BETHLEHEM PUBLIC LIBRARY
PARKING AND CIRCULATION IMPROVEMENTS
SED CONTROL NO: 01-03-06-06-021-007
451 DELAWARE AVENUE
DELMAR, NEW YORK

LIGHTING & ELECTRICAL LAYOUT PLAN

Drawing No. CLA-6

| REVISION NUMBER | REVISION DESCRIPTION | DRAWN BY | REVISIONS PER NYSED COMMENTS | CHECKED BY | DATE |
|-----------------|--|----------|------------------------------|------------|---------|
| | Revisions per Bethlehem Library Change Order #1 Bethlehem Sidewalk Addition | | | | |

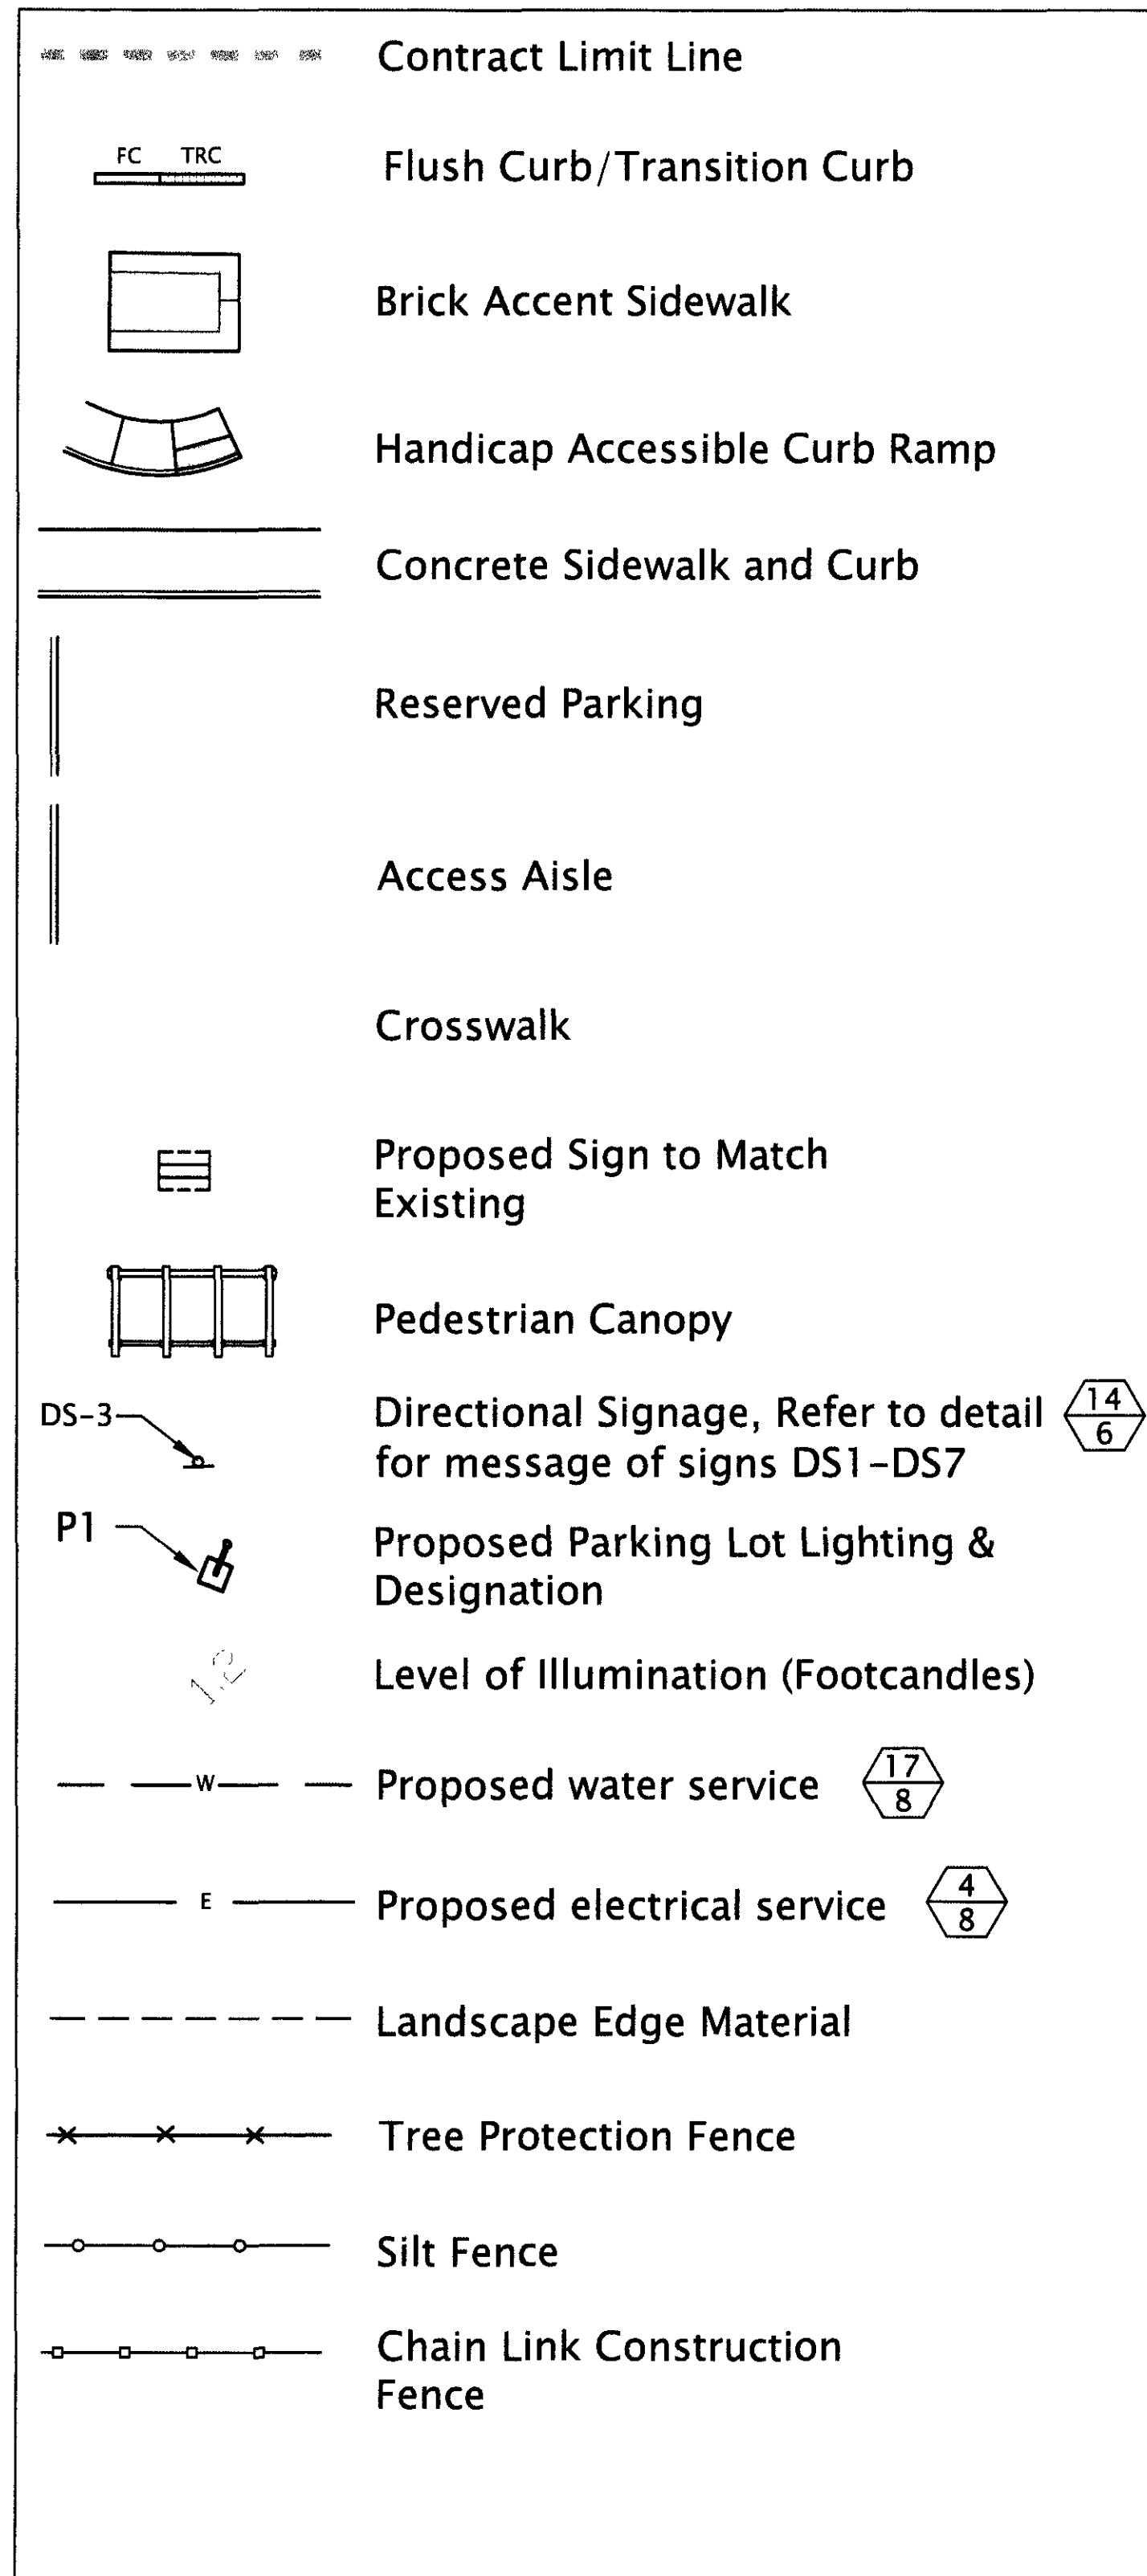
CHANGE ORDER #1

ELECTRICAL SERVICE FOR ALL PARKING LOT LIGHTS SHOWN ON ONE CIRCUIT. ELECTRICAL SYSTEM NEEDS TO BE PLACED ON MORE THAN ONE CIRCUIT. COORDINATE LOCATIONS OF ANY ADDITIONAL CONDUIT THAT MAY BE REQUIRED WITH LANDSCAPE ARCHITECT.

CONTRACTOR TO CONNECT ELECTRICAL SERVICE INTO EXISTING CIRCUIT PANEL. SEE NOTE 7. PARKING LOT LIGHTING AND SHED SERVICE TO BE ON SEPARATE CIRCUITS.
